APPENDIX 6

Comments and Responses on Proposed 2016 Monitoring Network Plan, Revision 0

COMMENTS AND RESPONSES ON
PROPOSED 2016 MONITORING NETWORK PLAN, REVISION 0

The public comment period for the proposed 2016 Missouri Monitoring Network Plan opened on May 27, 2016 and closed on June 28, 2016. The Missouri Department of Natural Resources' Air Pollution Control Program prepared the 2016 Monitoring Network Plan to address the requirements of 40 CFR 58.10 (a) (1) for annual submittal of a plan to provide information on current State or Local Air Monitoring Stations (SLAMS), other ambient air monitoring, and any proposed network changes for the upcoming year.

Figure 1. Expected peak concentration areas per Ameren's original modeling.

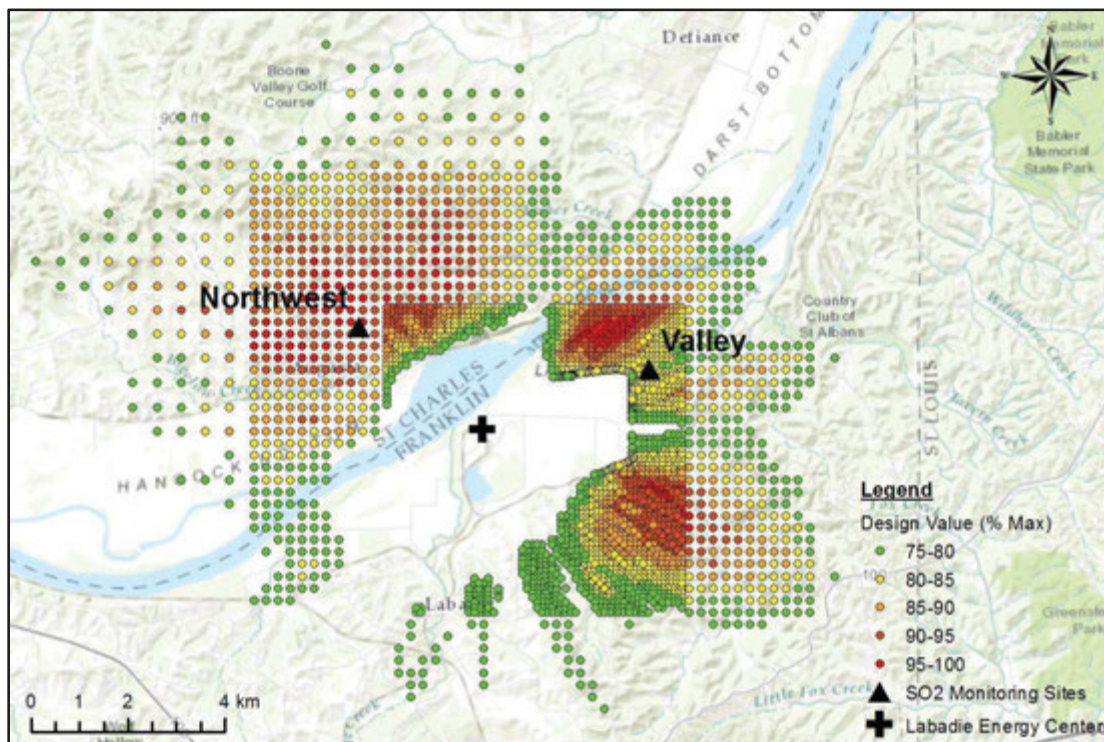
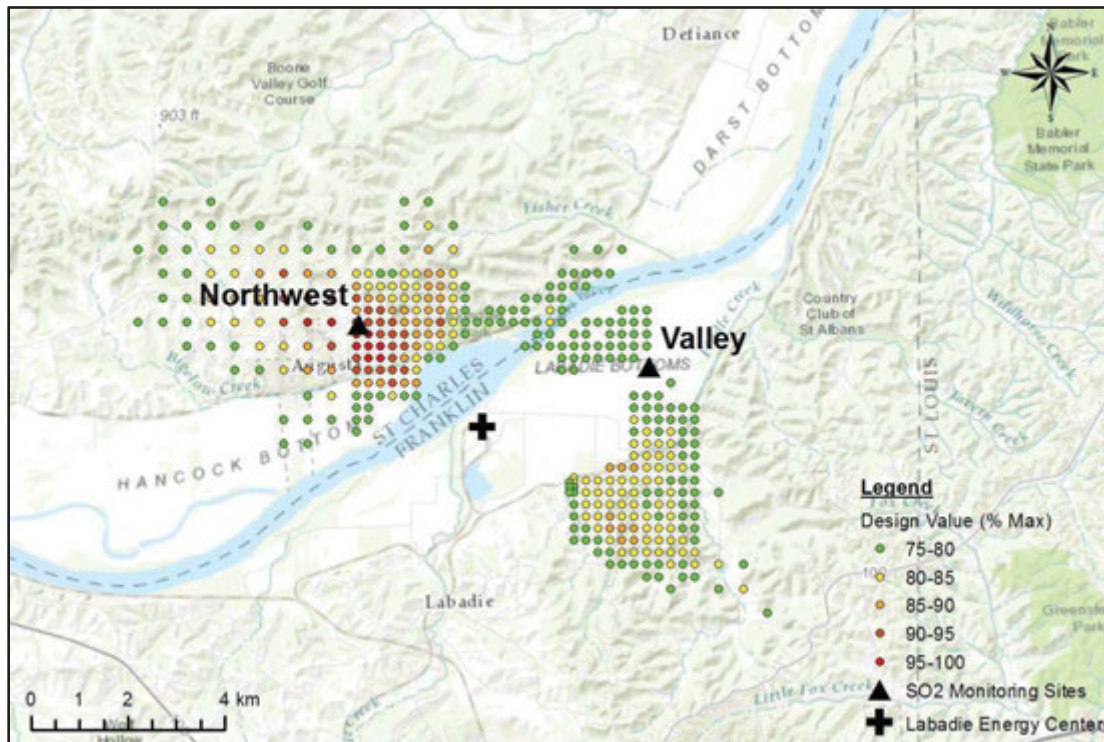
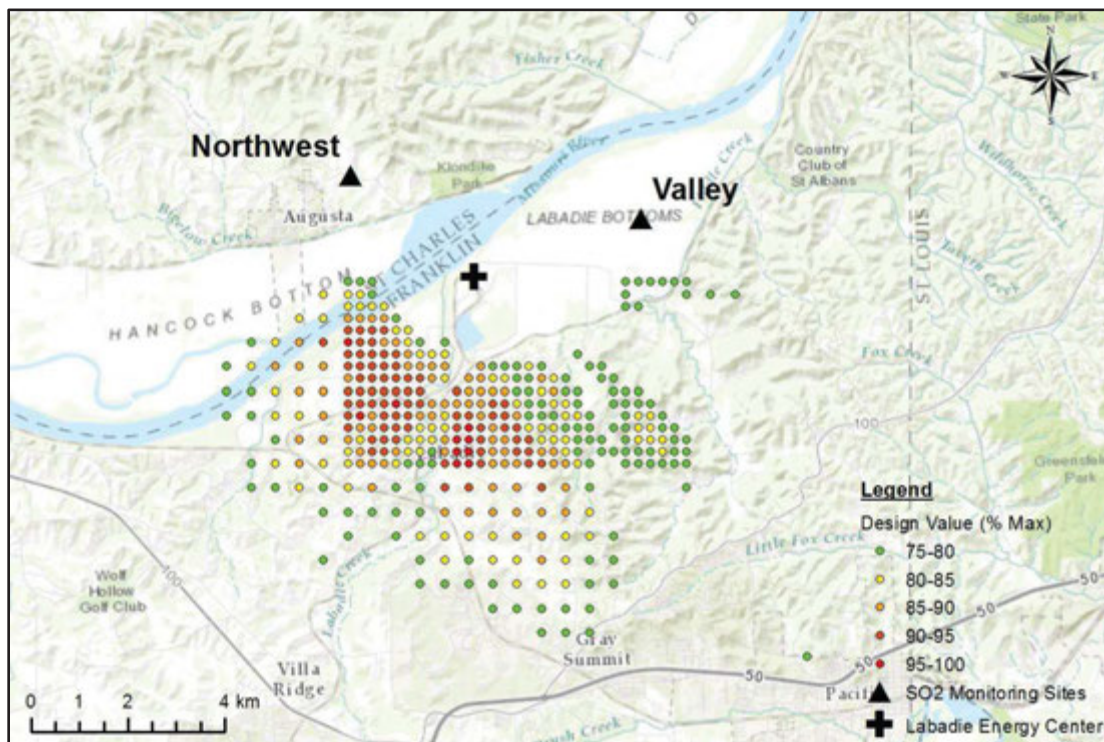
As demonstrated in comment letters previously submitted on behalf of Sierra Club, one or both of Ameren's Labadie monitors are not in areas of expected peak concentrations, and a third monitor is also needed.⁹ Our previous comments, which are attached as Exhibits 1-5 and incorporated herein by reference, highlighted the following key points:

- Ameren's original modeling to site the monitors identified three distinct areas where peak 1-hour SO₂ concentrations are expected to occur. These areas are located northwest, northeast, and southeast of the plant and are shown in Figure 1. However, only one of the monitors – the Northwest monitor – is located in one of these areas. No monitor is located in either of the other two peak concentration areas. The Valley monitor is located between the two unmonitored peak concentration areas, at a site where the modeled concentration is approximately 20 percent lower than in the peak areas.

- DNR's modeling for its proposed Labadie designation recommendation, which used newer emissions and meteorological data than Ameren's original modeling, confirmed that the Valley monitor is not located in an expected peak concentration area and predicted an even lower concentration (relative to the peak) at the Valley monitoring site than Ameren's original modeling. This is shown in Figure 2.

Figure 4. Design values and score ranks for the top 300 receptors, DNR modeling based on 2012-2014 emissions.

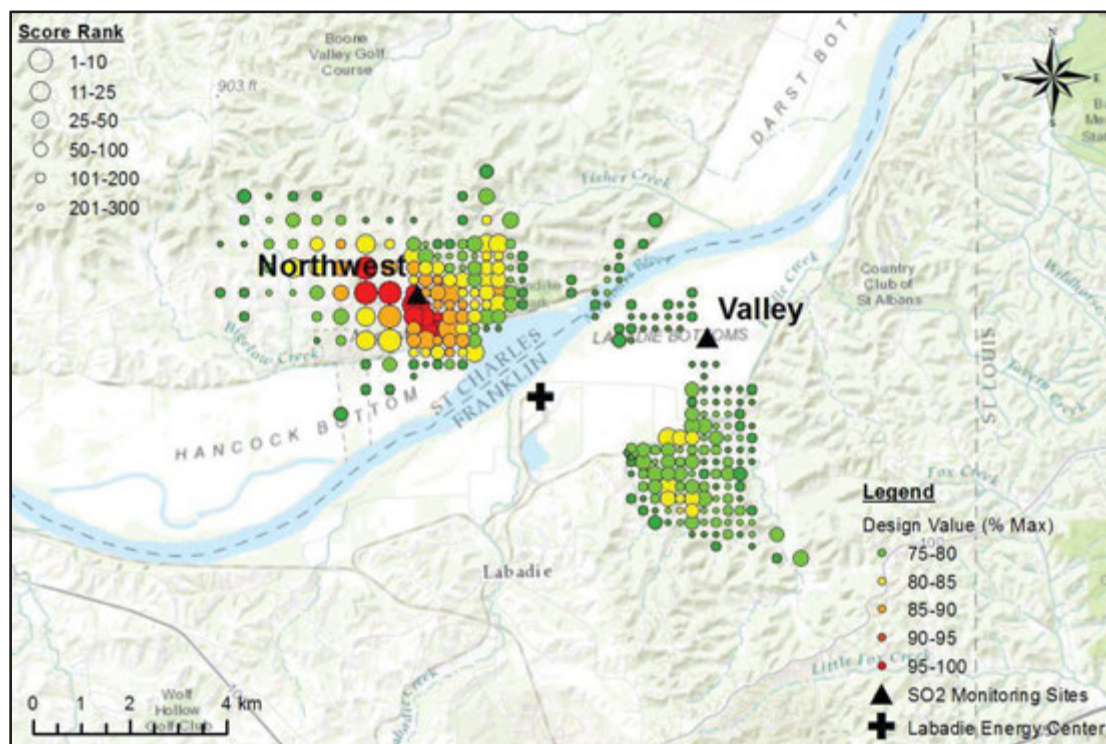
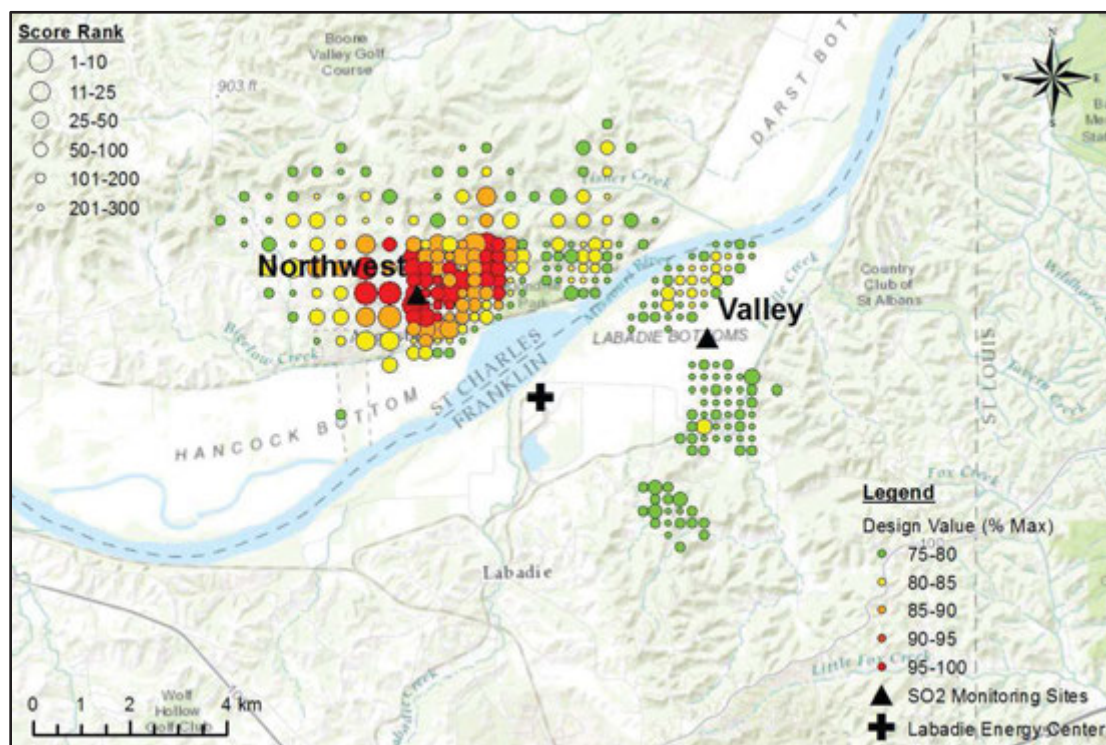
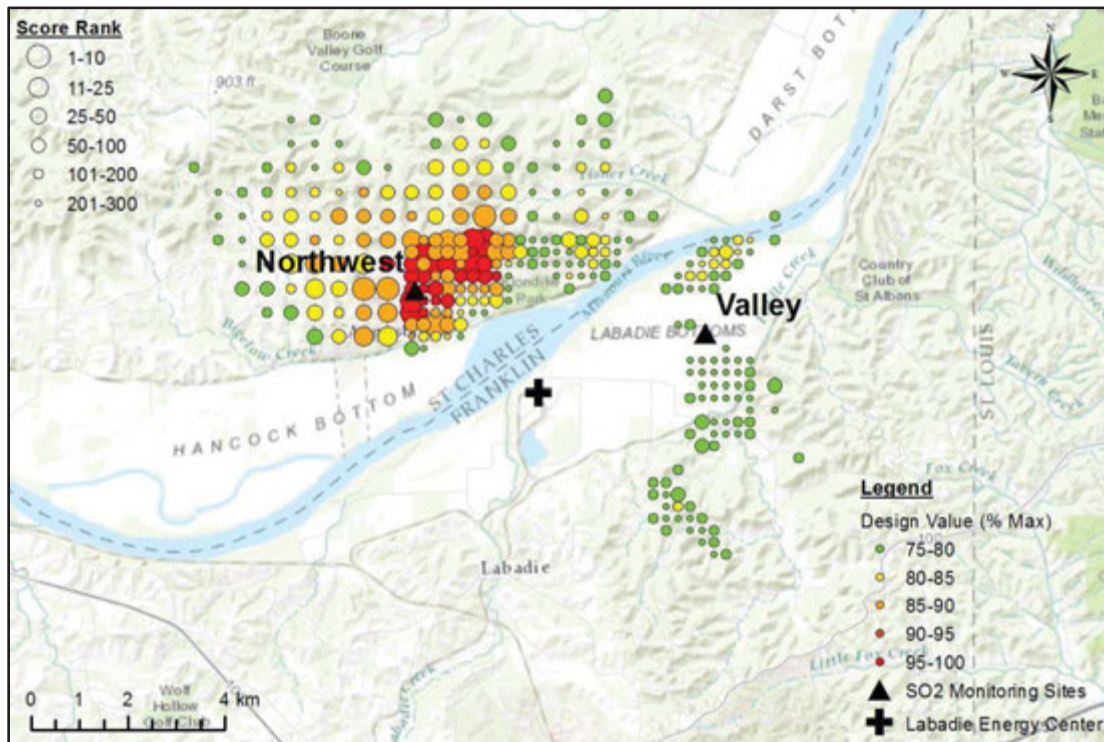
Had DNR analyzed Ameren's Labadie monitoring sites using this strategy in either its original modeling, which used 2012-2014 emissions data, or its updated modeling, which used 2013-2015 emissions data and also included a new variant with a merged stack for units 3 and 4, it would have found – as shown in our comments on the 2015 Monitoring Network Plan (Ex. 2 attached hereto) – that the Valley monitor is not sited in an expected peak concentration area and needs to be relocated. We obtained DNR's original and updated modeling via Sunshine Law request and reviewed the results in order to identify the 300 receptors with the highest modeled design values. Next, as DNR did in its supplemental analysis of the Rush Island monitoring sites, we reran the models for the top 300 receptors using the MAXDAILY output option in AERMOD to determine the maximum 1-hour concentration for each receptor for each day and then tallied the number of days each receptor had the highest 1-hour daily maximum concentration among all receptors.¹⁴ Then, we ranked the top 300 receptors by both design value (concentration rank) and the number of days each had the highest 1-hour daily maximum concentration (day rank) and calculated a score for each one by adding its concentration rank and its day rank. Finally, we ranked the receptors by their scores to create a list of receptor locations in general order of desirability with regard to monitor siting. Figures 4, 5, and 6 show modeled design values and receptor score ranks for the top 300 receptors for DNR's original and updated modeling.

Figures 4, 5, and 6 all show that while the Northwest monitor is sited in an area with high modeled design values and numerous highly ranked receptors, the Valley monitor clearly is not. Regardless of which modeling is used in the analysis, the Valley monitor is sited in an area where there are no top 300 receptors and where the modeled design value is generally less than 75% of the maximum. As such, its location is not on the prioritized list of receptor locations for permanent monitoring sites developed using the scoring strategy described in TAD, and DNR should require that it be moved to a location that is. Figure 4 (based on DNR's modeling with 2012-2014 emissions) shows a large cluster of highly-ranked receptors, including several in the top 25 and many in the top 50, south of the Valley monitor, while Figures 5 and 6 (based on DNR's modeling with 2013-2015 emissions) show a smaller cluster of top 100/200 receptors north of the Valley monitor. It should be noted that, as we discussed in our April 2015 comments on the Labadie QAPP, Ameren's original analysis of the Labadie monitoring sites showed very high modeled design values in both of these areas, yet Ameren still chose to site the Valley monitor where modeled design values were considerably lower.

Figure 7. Design values and score ranks for the top 300 receptors, Ameren modeling based on 2013-2015 emissions, KJEF met, and East St. Louis background.

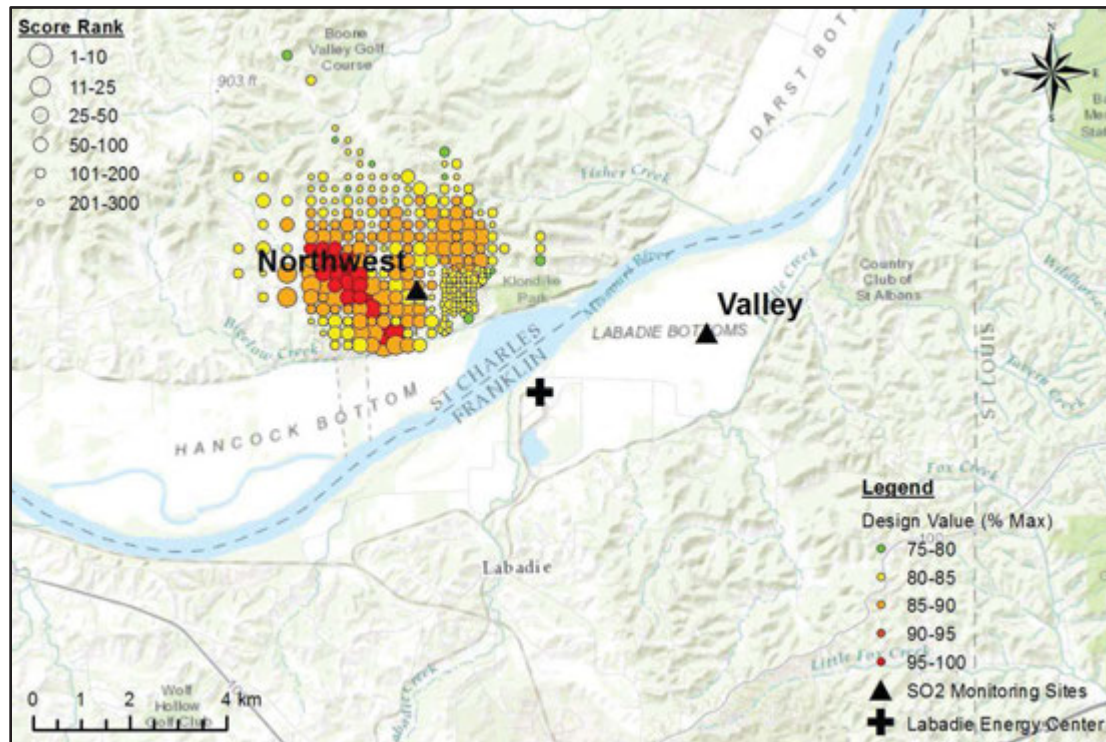
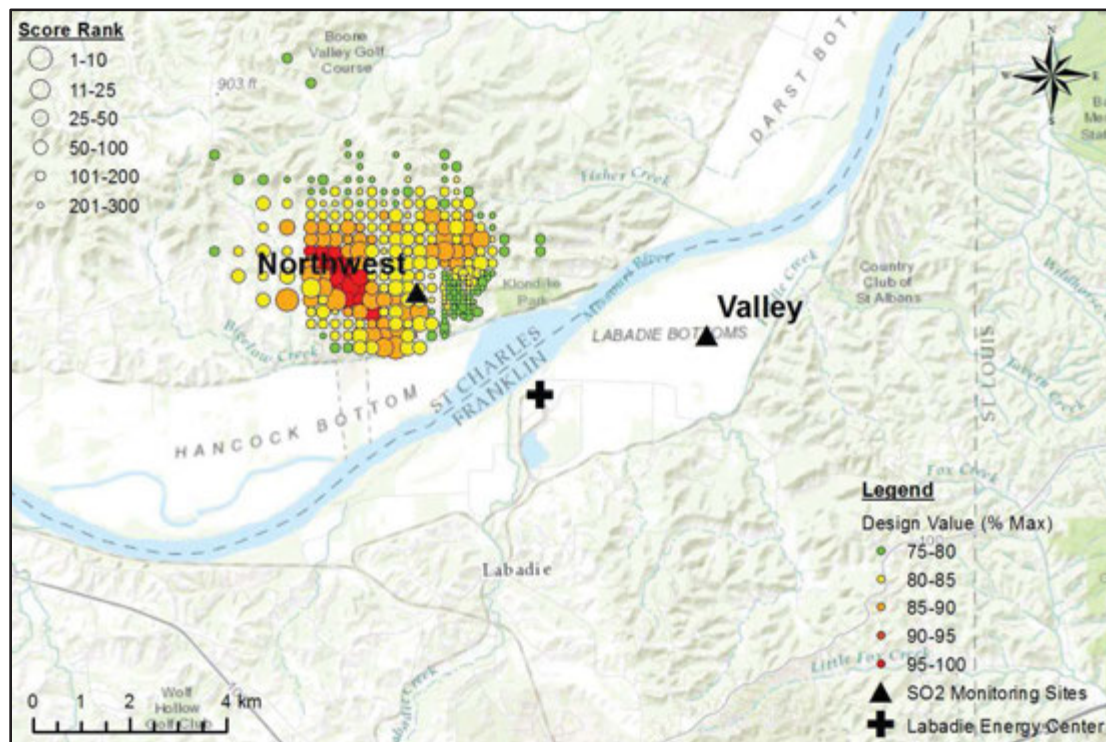
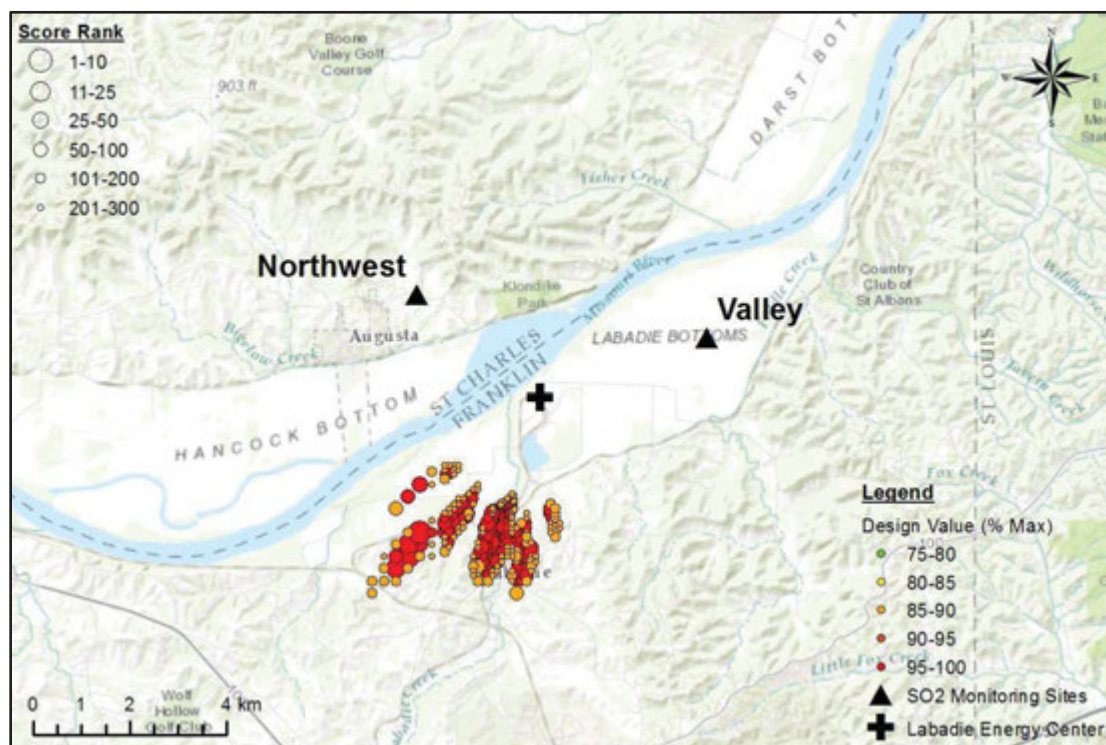
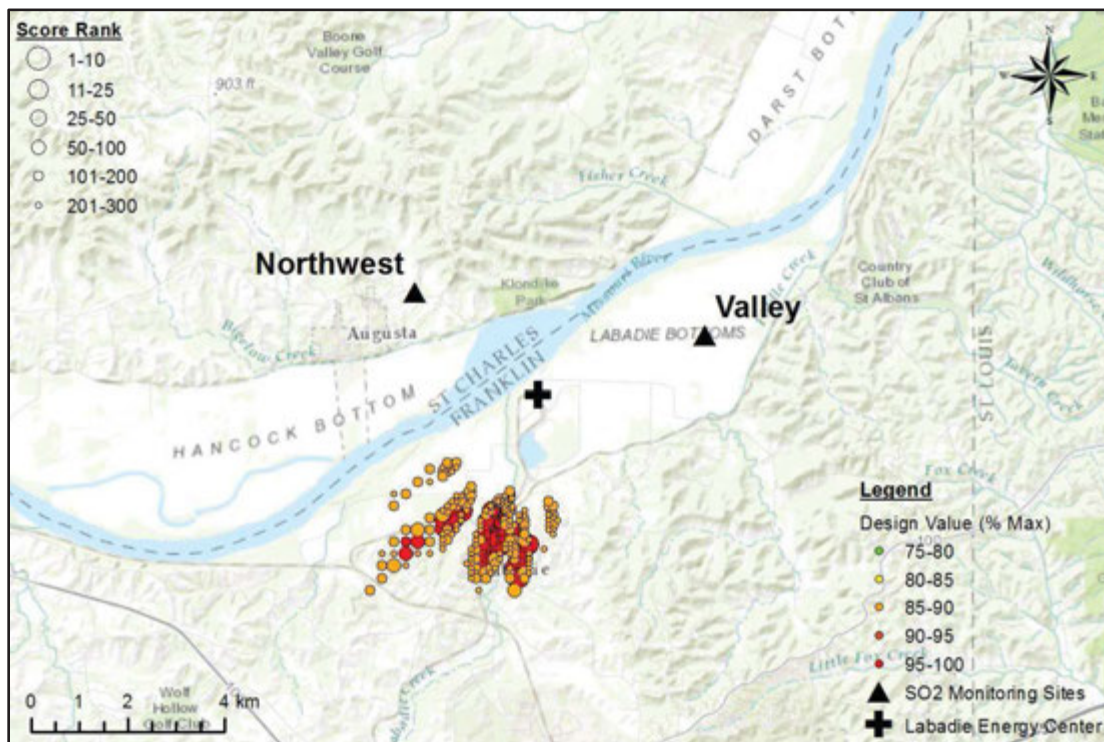
A similar analysis of Ameren's most recent modeling supports not only relocating the Valley monitor but also adding at least one monitor southwest of the plant. In late March, in response to the EPA's proposed nonattainment designation for Labadie, Ameren submitted a host of new modeling runs using 2013-2015 emissions data. Half of the new runs used a non-default beta option in AERMOD that EPA has not approved for use at Labadie. Therefore, we did not analyze those runs. Of the four remaining runs, all of which appropriately used AERMOD's regulatory default options, two used meteorological data from the same National Weather

Service (“NWS”) station that DNR used (Jefferson City Memorial Airport (KJEF)). Figures 7 and 8 show modeled design values and receptor score ranks for the top 300 receptors for these runs. The other two runs used meteorological data from the NWS station at Spirit of St. Louis Airport (KSUS). Figures 9 and 10 show modeled design values and receptor score ranks for the top 300 receptors for these runs.

Because Ameren used a much finer receptor spacing than DNR, Ameren's top 300 receptors are much more concentrated than DNR's, limiting to some degree the conclusions that can be drawn from Ameren's modeling without swapping out Ameren's receptor grid for DNR's and re-running Ameren's models. Still, Figures 7 and 8 show that based on Ameren's KJEF model runs, the Valley monitor is sited where there are no highly ranked receptors and the modeled design value is less than 75% of the maximum. Hence, these runs support the conclusion – drawn from our analysis of DNR's latest modeling – that the Valley monitor should be relocated.

Figures 9 and 10, on the other hand, show that based on Ameren's KSUS model runs, *neither* of the Labadie monitors is sited in an expected peak concentration area. The highest modeled design values, as well as the highest ranked receptors, are located south-southwest of the plant. There are no highly ranked receptors, and modeled design value are generally less than 75% of the maximum, at both the Valley and Northwest monitoring sites. As demonstrated in our supplemental comments on the 2015 Monitoring Network Plan (Ex. 3 attached hereto) preliminary meteorological data from the Valley site indicate that KSUS meteorological data is more representative of meteorological conditions at Labadie than KJEF meteorological data. Given that expected peak concentration areas are dramatically different when KSUS meteorological data are used, DNR should require one or more additional monitors in the peak concentration areas shown in Figures 9 and 10 in addition to the two existing monitors (one of which should be relocated). Failure to monitor these areas would result in failure to detect ground-level SO₂ concentrations maxima if KSUS meteorological data ultimately prove more representative of the area than KJEF meteorological data.

Figure 11. Expected peak concentration areas per Ameren’s modeling for its analysis of SO₂ and meteorological monitoring sites around Rush Island.

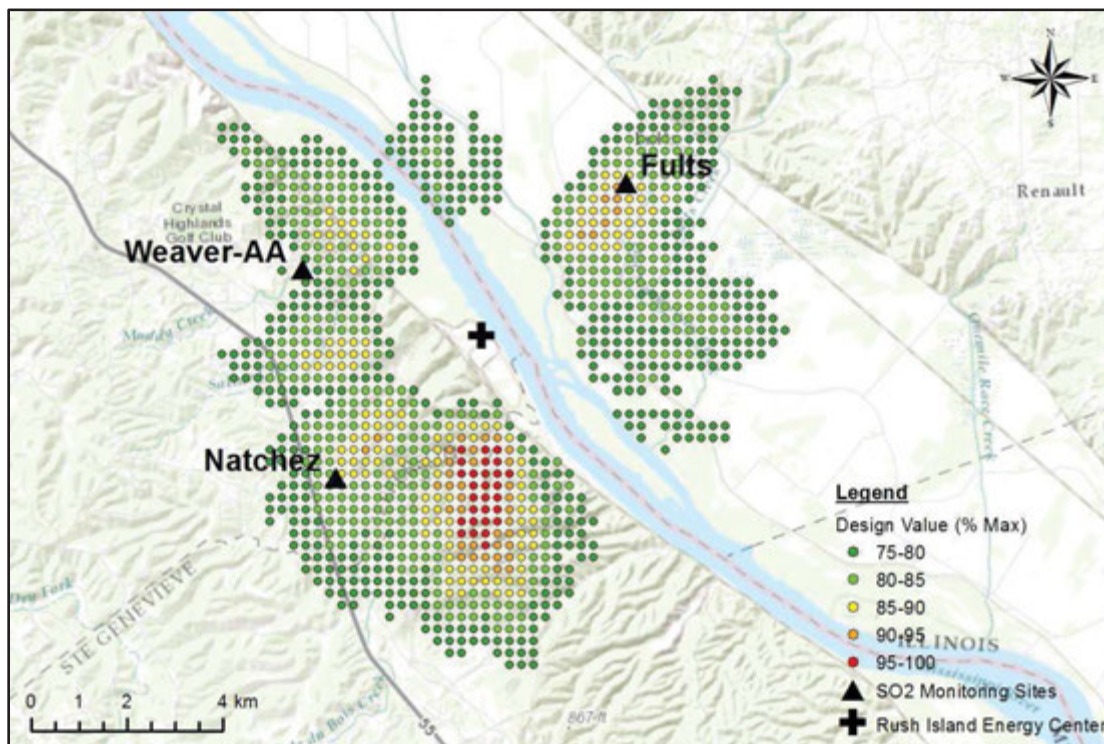
- Ameren's modeling for its analysis of SO₂ and meteorological monitoring sites around Rush Island identified one large and four smaller areas where peak 1-hour SO₂ concentrations are expected to occur. These areas are shown in Figure 11. However, none of the Rush Island monitors are located in the large peak concentration area south of the plant, which is also where the highest modeled concentrations occur. Furthermore, while two of the monitors – Fults and Natchez – are located on the periphery of two of the smaller expected peak concentration areas, the Weaver-AA monitor is not located in an expected peak concentration area at all.
